Nuclear Innovation  
North America LLC  
122 West Way, Suite 405  
Lake Jackson, Texas 77566

July 24, 2014  
U7-C-NINA-NRC-140021

South Texas Project  
Units 3 and 4  
Docket No. 52-012 and 52-013  
Response to Request for Additional Information

**REVISED RESPONSE TO RAI 08.02-25 and 08.02-26:**

Figure 1

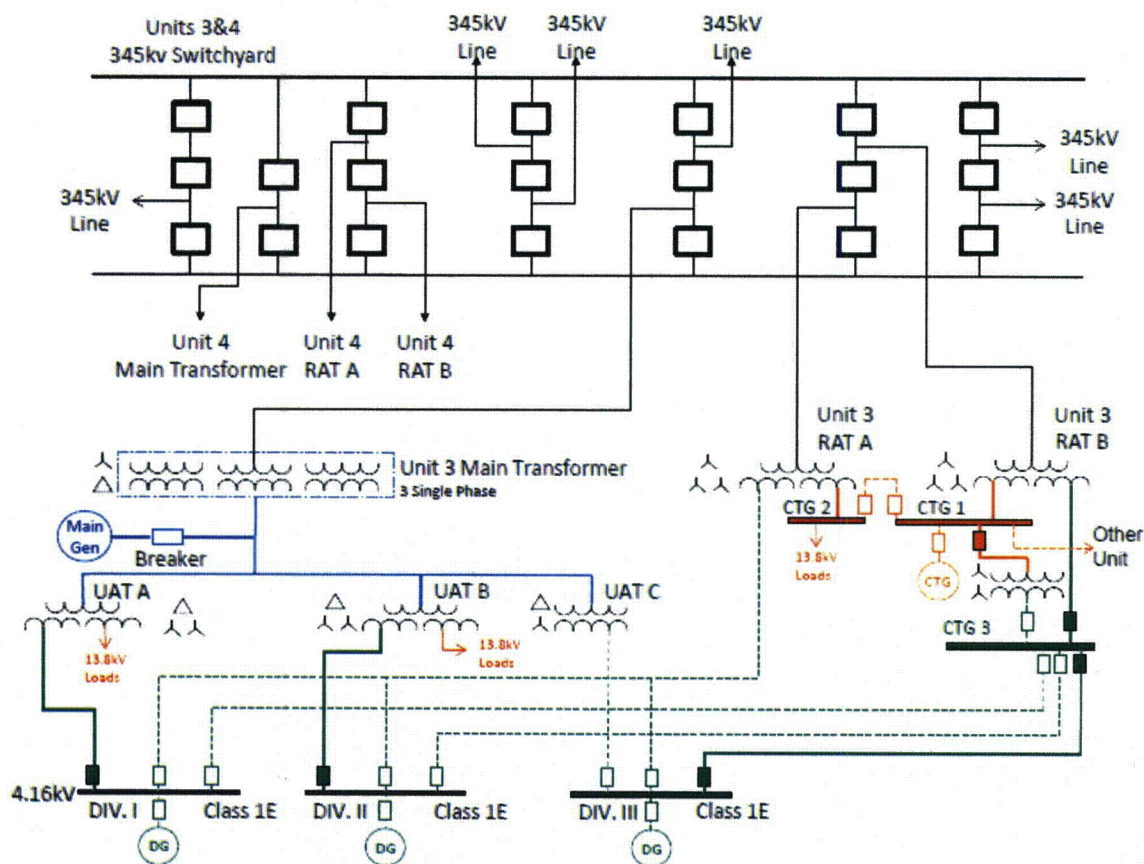
The STP 3&4 onsite and offsite electrical power system is shown in Figure 1. The electrical design includes three separate offsite power supplies for each unit. The three offsite power supplies are connected to the onsite power distribution system via three transformers - a Main Power Transformer (MPT) and two Reserve Auxiliary Transformers, RAT-A and RAT-B. During power operation the main generator output is sent to the offsite grid via the MPT and a portion of the output supplies three unit auxiliary transformers (UATs) which in turn supply two Class 1E 4.16 kV busses. Since each unit has a main generator circuit breaker, on a main generator trip, the UATs and the two Class 1E 4.16 kV busses are automatically back fed from the offsite grid via the MPT. The third Class 1E 4.16 kV bus is normally supplied by RAT-B. RAT-A is connected to the offsite grid in a standby mode and can be readily aligned from the Main Control Room to supply all three of the Class 1E 4.16 kV busses. The STP 3&4 electrical distribution system does not utilize any automatic bus transfer schemes.

- ***If the important to safety buses are not powered by offsite power sources during at power condition, explain how the surveillance tests are performed to verify that a single-phase open circuit condition or high impedance ground fault condition on an off-site power circuit is detected.***

The Class 1E 4.16 kV safety busses at STP 3&4 are normally powered by offsite power sources during at power conditions. As shown in Figure 1, two of the Class 1E 4.16 kV busses are supplied with power from the main generator through the unit auxiliary transformers. The third Class 1E 4.16 kV bus is supplied from RAT-B. RAT-A is normally unloaded and in a standby mode. Open phase detection and alarm is provided for all three transformers (MPT, RAT-A, RAT-B) that are connected to the offsite grid.
